UNITED STATES PATENT AND TRADEMARK OFFICE

APPLICATION NO.	FILING DATE	FIRST NAMED INVENTOR	ATTORNEY DOCKET NO.	CONFIRMATION NO.
09/842,631	04/27/2001	Wendong Zhen	925-192	8827
23117	7590	05/03/2004	EXAMINER	
NIXON & VANDERHYE, PC 1100 N GLEBE ROAD 8TH FLOOR ARLINGTON, VA 22201-4714			DIAZ, JOSE R	
			ART UNIT	PAPER NUMBER
			2815

Office Action Summary

DETAILED ACTION

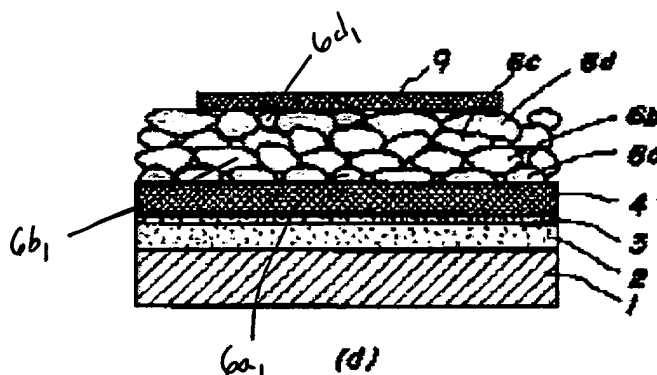
Regarding claims 23, Ogata et al. teaches a lower electrode (4) (see fig. 3d) laminated on one side to a substrate (1) (see fig. 3d), a ferroelectric thin film (6) constructed of at least three layers (see fig. 3d) including a lowermost layer (6a) (see fig. 3d), an intermediate layer (6b) (see fig. 3d), and an uppermost layer (6d) (see fig. 3d); and an upper electrode (9) only being directly laminated, on one side, to said uppermost layer (6d) (see fig. 3d), so that said intermediate layer (6b) does not directly contact either said lower electrode (4) or said upper electrode (9) (see fig. 3d), wherein a crystal grain (6d₁) of the uppermost layer (6d) is smaller than a crystal grain (6b₁) of the intermediate layer (6b) (see figure below).

Regarding claim 24, Ogata et al. teaches that a crystal grain ($6a_1$) of the lowermost layer (6a) and a crystal grain ($6d_1$) of the uppermost layer (6d) are smaller than a crystal grain ($6b_1$) of the intermediate layer (6b) (see figure below).

Regarding claims 28, Ogata et al. teaches a lower electrode (4) (see fig. 3d) laminated on one side to a substrate (1) (see fig. 3d), a ferroelectric thin film (6) constructed of at least three layers (see fig. 3d) including a lowermost layer (6a) (see figure 3d), an intermediate layer (6b) (see figure 3d), and an uppermost layer (6d) (see figure 3d); and an upper electrode (9) only being directly laminated, on one side, to said uppermost layer (3d) (see fig. 3d), so that said intermediate layer (6b) does not directly contact either said lower electrode (4) or said upper electrode (9) (see fig. 3d), wherein the lower most layer (6a) being formed of uniform minute crystal grains having small pinhole size gaps therebetween (consider the space between adjacent grains) and with a crystalline nucleus density of the lowermost layer (6a) being higher than those of the intermediate layer (6b) and an uppermost layer (6d) (see figure 3d).

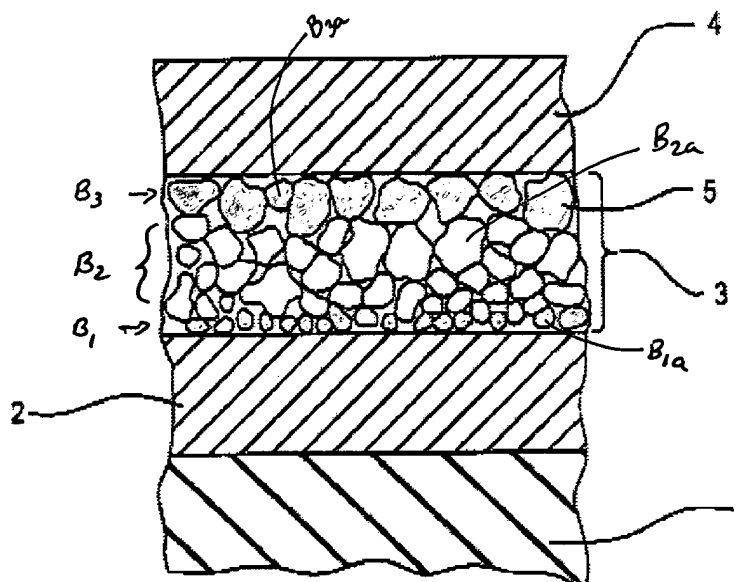
Regarding claims 23, Shimada et al. teaches a lower electrode (2) (see fig. 7) laminated on one side to a substrate (1) (see fig. 7), a ferroelectric thin film (3) constructed of at least three layers (see fig. 7) including a lowermost layer (B_1) (see figure below), an intermediate layer (B_2) (see figure below), and an uppermost layer (B_3) (see figure below); and an upper electrode (4) only being directly laminated, on one side, to said uppermost layer (B_3), so that said intermediate layer (B_2) does not directly contact either said lower electrode (2) or said upper electrode (4) (see fig. 7), wherein a crystal grain (B_{3a}) of the uppermost layer (B_3) is smaller than a crystal grain (B_{2a}) of the intermediate layer (B_2) (see figure below).

Regarding claim 24, Shimada et al. teaches that a crystal grain (B_{1a}) of the lowermost layer (B_1) and a crystal grain (B_{3a}) of the uppermost layer (B_3) are smaller than a crystal grain (B_{2a}) of the intermediate layer (B_2) (see figure below).

Regarding claims 28, Shimada et al. teaches a lower electrode (2) (see fig. 7) laminated on one side to a substrate (1) (see fig. 7), a ferroelectric thin film (3) constructed of at least three layers (see fig. 7) including a lowermost layer (B_1) (see figure below), an intermediate layer (B_2) (see figure below), and an uppermost layer (B_3) (see figure below); and an upper electrode (4) only being directly laminated, on one side, to said uppermost layer (B_3), so that said intermediate layer (B_2) does not directly contact either said lower electrode (2) or said upper electrode (4) (see fig. 7), wherein the lower most layer (B_1) being formed of uniform minute crystal grains having small

pinhole size gaps therebetween (consider the space between adjacent grains) and with a crystalline nucleus density of the lowermost layer (B_1) being higher than those of the intermediate layer (B_2) and an uppermost layer (B_3) (see figure below).

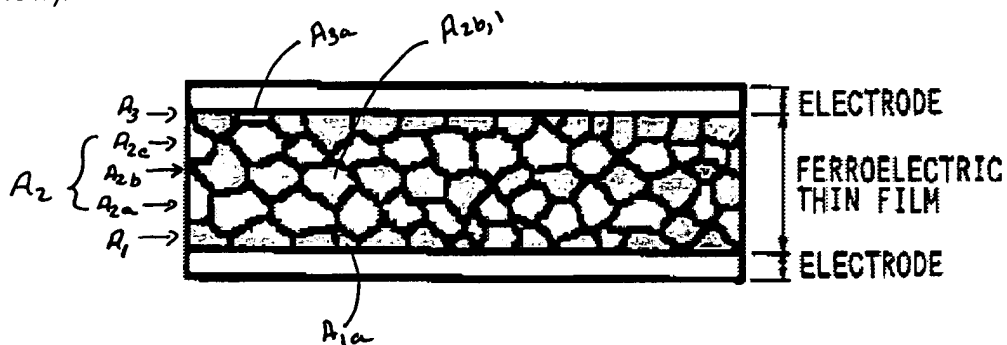
Regarding claims 23, 30 and 32, Suzuki teaches a lower electrode (consider the "ELECTRODE" under the ferroelectric thin film in fig. 7) laminated on one side to a substrate (1) (see abstract), a ferroelectric thin film ("FERROELECTRIC THIN FILM") constructed of at least three layers (see fig. 7) including a lowermost layer (A_1) (see figure below), an intermediate layer (A_2) (see figure below), and an uppermost layer (A_3) (see figure below); and an upper electrode (consider the "ELECTRODE" above the ferroelectric thin film in fig. 7)) only being directly laminated, on one side, to said uppermost layer (A_3), so that said intermediate layer (A_2) does not directly contact either

said lower electrode or said upper electrode (see fig. 7). Furthermore, Suzuki teaches a ferroelectric film having five layers: a lowermost layer (A_1), an uppermost layer (A_3), and three intermediate layers (A_{2a} , A_{2b} and A_{2c}), wherein a crystal grain (A_{1a} , A_{3a}) of at least one of the lowermost layer (A_1) and the uppermost layer (A_2) is smaller than a crystal grain ($A_{2b,1}$) of the intermediate layers (A_{2a} , A_{2b} and A_{2c}) (see figure below).

Regarding claims 24 and 31, Suzuki teaches that a crystal grain (A_{1a}) of the lowermost layer (A_1) and a crystal grain (A_{3a}) of the uppermost layer (A_3) are smaller than a crystal grain ($A_{2b,1}$) of the intermediate layers (A_{2a} , A_{2b} and A_{2c}) (see figure below).
